Access Compliance Report Public Rights-of-Way (Curb Ramps)

Main Street: WINDSOR_LN Cross Street: RED_HILL_AVE Location: SE

ADA ID: RPRK211014173116 Ramp Type: Type 7 - Directional 2 Initial Pass/Fail: Fail Overall Compliance: No Severity Score: 16

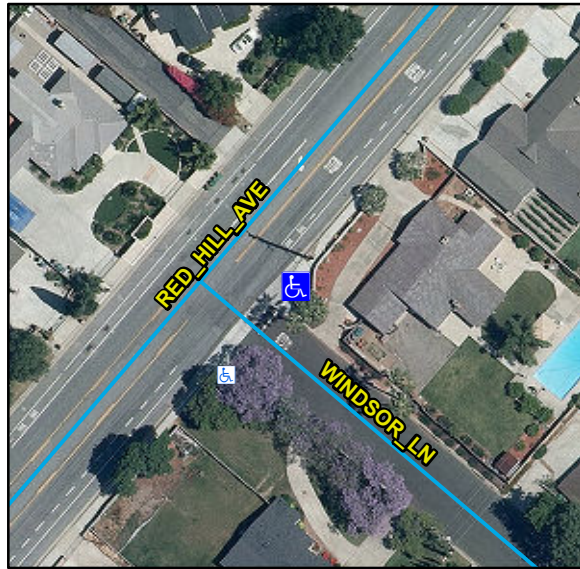
Compliance	Description	Data	Compliance	Description	Data
N/A	Ramp Length (in)	190	N/A	Flare Type LT	
Yes	Ramp Width (in)	48			N/A
Yes	Ramp Run Slope (%)	8.6	N/A	Flare Slope LT (%)	N/A
No	Ramp Cross Slope (%)	2.1	N/A	Flare Traversable LT	N/A
N/A	Grade Break	N/A	N/A	Flare Type RT	
N/A	Grade Break Slope (%)	N/A			N/A
N/A	Grade Break Cross Slope (%)	N/A	N/A	Flare Slope RT (%)	N/A
	Addl Para Ramp Left?	No	N/A	Flare Traversable RT	N/A
	Addl Para Ramp Right?	No	N/A	DWS Provided	N/A
N/A	Landing Present	N/A	N/A	DWS Contrast	N/A
N/A	Landing Length (in)	N/A	N/A	DWS Length (in)	N/A
N/A	Landing Width (in)	N/A	N/A	DWS Full Width	N/A
N/A	Landing Run Slope (%)	N/A		DWS Offset Type	N/A
N/A	Landing Cross Slope (%)	N/A	N/A	DWS Left Offset (in)	N/A
N/A	Landing Movement Obstructed?	N/A	N/A	DWS Right Offset (in)	N/A
	Landing Movement Type	N/A			
N/A	Landing Shared	N/A			
N/A	Marked Crosswalk 1	No	N/A	Clear Space	N/A
	Crossing 1 Direction	SW	N/A	Clear Space To Crosswalk (in)	N/A

Marked Crosswalk 1 Width (in)	N/A			
N/A	Ramp Inside Crosswalk 1	N/A			
	Crossing 1 Slope (%)	1.1			
	Crossing 1 Cross Slope (%)	3.4			
N/A	Gutter Ponding	N/A	N/A	Curb Slope	10.5
Yes	Gutter Lip Height (in)	0		Road Run Slope (%)	N/A
N/A	Gutter Run Slope (%)	N/A		Road Cross Slope (%)	N/A
N/A	Gutter Cross Slope (%)	N/A		Parallel Ramp Side	Right
Yes	Overall Surface Condition	Acceptable	Yes	Perp Joint Present	Yes
	Cross Gutter Present?	Yes		Spandrel Present?	Yes
	Replace Cross Gutter?	No		Replace Spandrel?	No

Remove & Replace Entire Ramp.
